SERVICE INSTRUCTION

SI0027 Rev B

SUBJECT: *Cabin Heat Retrofit Kit*

MODELS AFFECTED: *CC11-160 (S/N 11-00093 through 11-00236)*

Figure 1

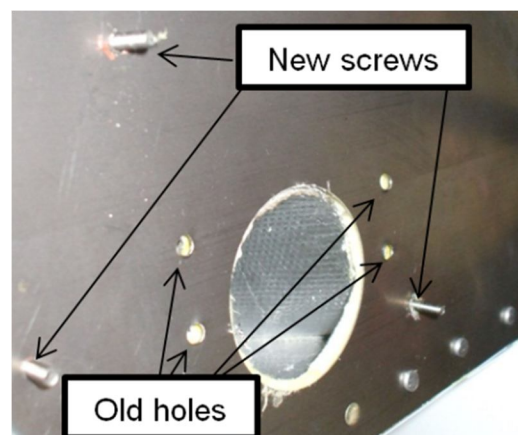
5. Using the Template 1, layout and drill three #28 mounting holes in the firewall for the new cabin heat box. See Figure 1.

Figure 2

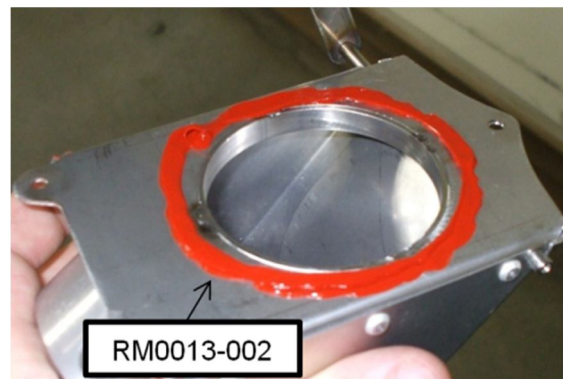
6. Apply a small bead of High Temp RTV around the perimeter of the round hole in the Cabin Heat Box (SC57350-003) (Figure 2), then mount the cabin heat box to the firewall using (3) AN507C632R8 screws, (3) HDW-A3236-012-935 countersunk washers, (3) AN960-6 flat washers and (3) AN363-632 high temp nuts. The screws should point towards the engine with the countersunk washers under the heads of the screws.

Figure 3

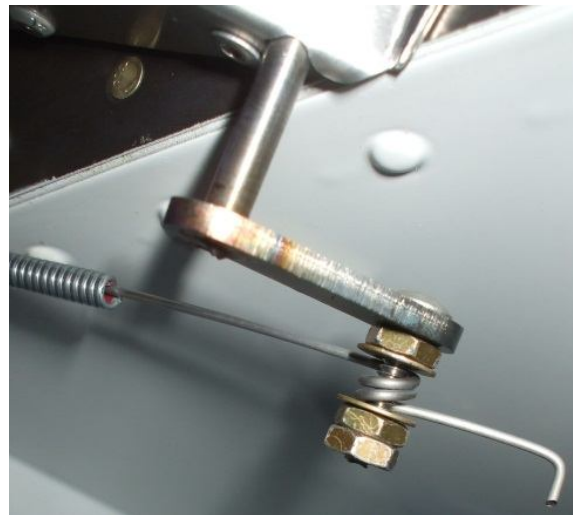
7. Install AN526C632R12 on arm of control box with an AN340-6 nut. Remove the nut holding the last cable clamp. Add 3 AN960-10 washers under the clamp and reinstall the clamp. Pull the housing through the other clamps on the firewall to get enough length to slip the loop in the wire over the stud (AN526C632R12) on the arm of the control box (Figure 3). Put one AN960-6 washer, the loop on the wire, a second AN960-6 washer, and then two AN340-6 nuts over the stud in the arm. The second of the two nuts acts as a jam nut. The wire loop should be able to rotate on the stud in the arm as the arm moves. Adjust the position of the cable housing in the last clamp on the firewall to ensure full travel of the door in the cabin heat control box. Install spiral wrap over cable housing where housing passes by the lower edge of the firewall.

Figure 4

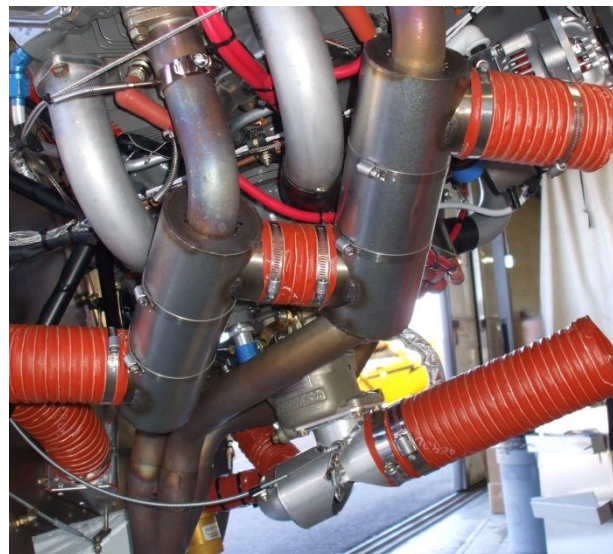
8. Install the new collectors (SC57330-001) by opening them up by hand just enough to slip them over the #1 and #3 exhaust pipes (Figure 4). Position the collectors on the straight section of each pipe and start two hose clamps (HDW-3720) on each collector (to reduce weight, two lightweight hose clamps are daisy-chained together to function as a single clamp). Connect the two collectors together with a piece of SCAT (RM0006-002) approx. 2 1/2" long and two hose clamps (HDW-100-215). Tighten all of the hose clamps while paying attention to how the ends of the collectors are lining up as well as the opening down the side of each collector. Do not over tighten the clamps. They should be just tight enough that the gaps on the end caps are gone and you cannot move the collector on the pipe.

Figure 5

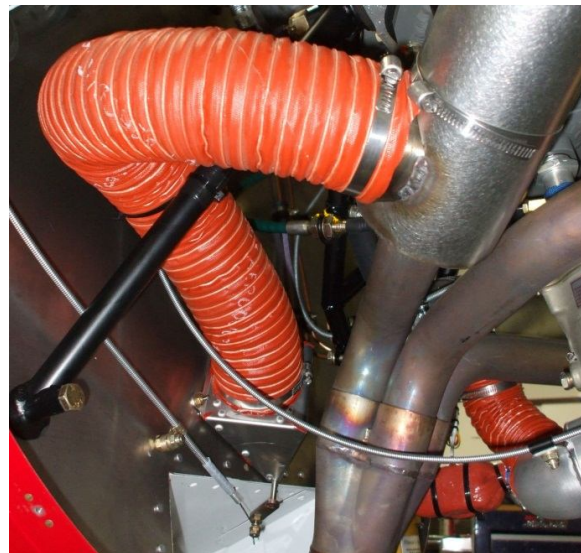
9. Clamp a piece of SCAT (RM006-002) approx. 20" long to the inlet on the new cabin heat control box and route it to the outlet of the collector on the #3 exhaust collector going above/behind the lower right tube on the engine mount (Figure 5). Wrap the engine mount with 1-2 layers of silicone chafe tape and secure the SCAT to the engine mount with cable ties. Ensure the SCAT does not contact any wires or control cables. Secure using cable ties as needed.

Figure 6

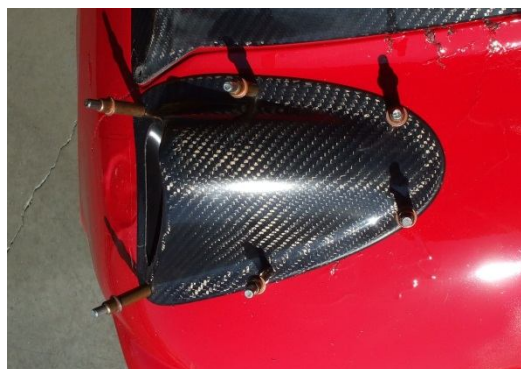
10. Using Template 2, layout and cut a hole in the right forward area of the lower cowling for the cabin heat air inlet insert (PC53026-001). Match drill #30 holes to the cowling using the insert as a jig and cleco clamps to hold it in place as you drill.

11. Remove the clecos, clean off any dust from drilling and cutting then screw the insert to the lower cowling using (6) AN507C632R8, (6) AN960-6 and (6) AN363-632.

Figure 9

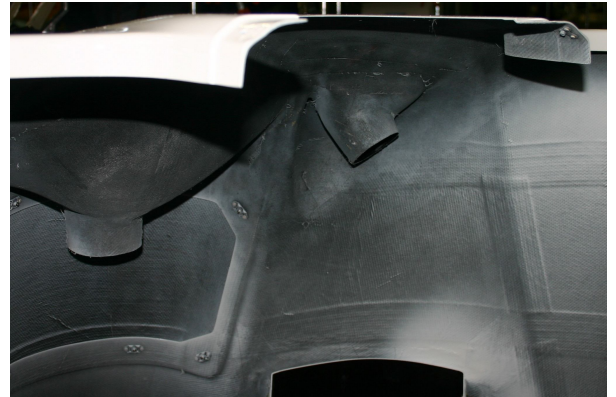
15. Secure Insert to Cowl with 1 ply of Glass Fiber Cloth (RM3733-001 or equivalent) and Fire Retardant Polyester Resin (RM7800-001 or equivalent). Allow resin to fully cure per product specification. **Bondo may be used to assist in initially securing Insert in place, and sticking Fiber Cloth to components.* (see Figure 9 for completed installation)

Firewall Drill Template

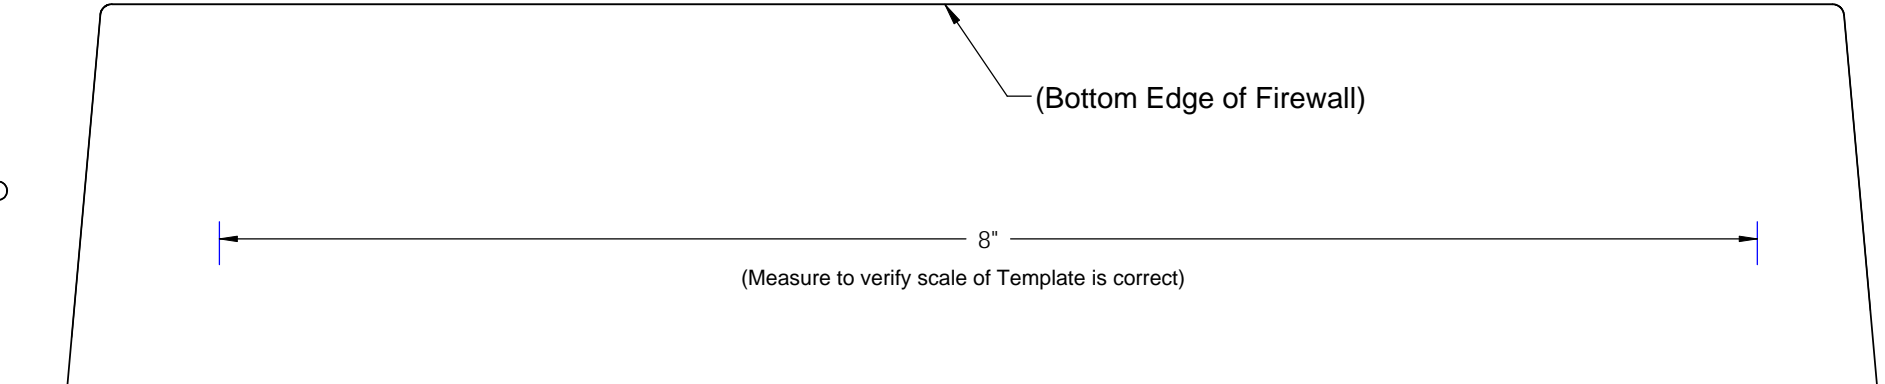
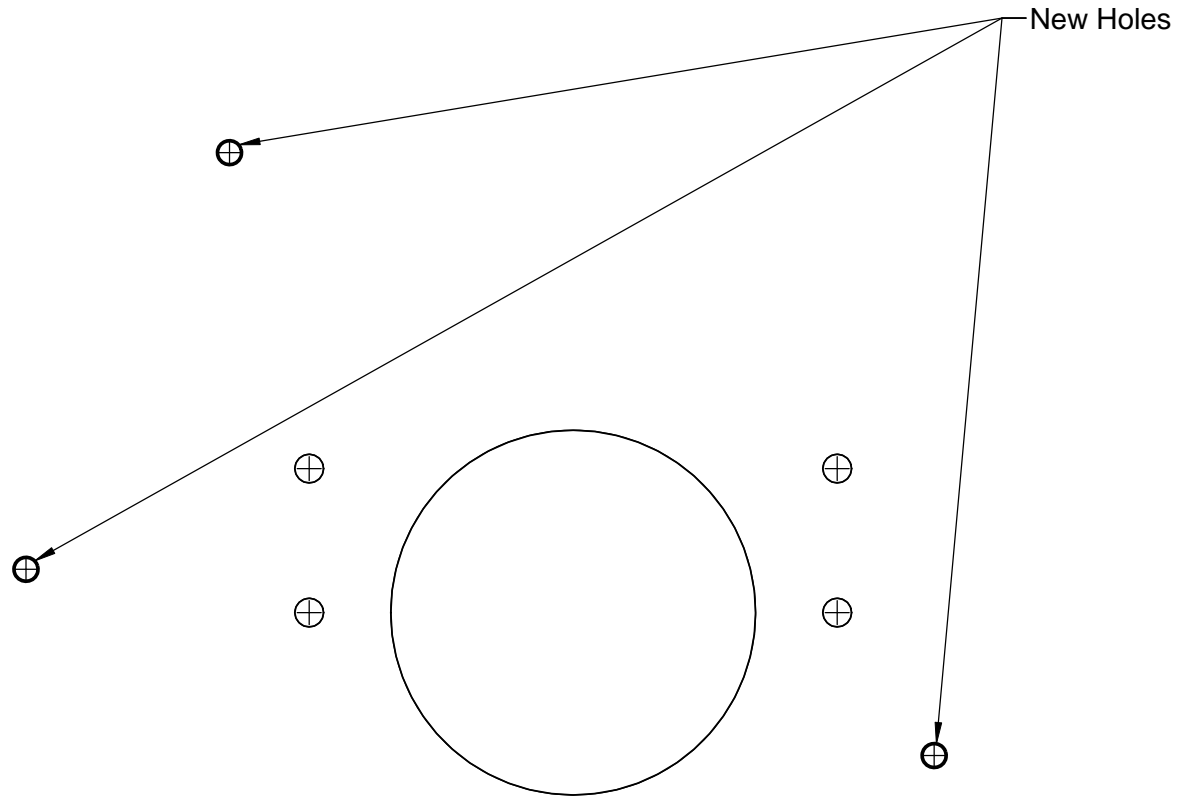
1. Verify scale of template by measuring 6" reference line at bottom of sheet
2. Cut out cross hatched sections of sheet.
3. Place template against lower right section of cowl and align with edge of Air Filter Retainer recess in cowl.
4. Trace cut-out onto cowl.
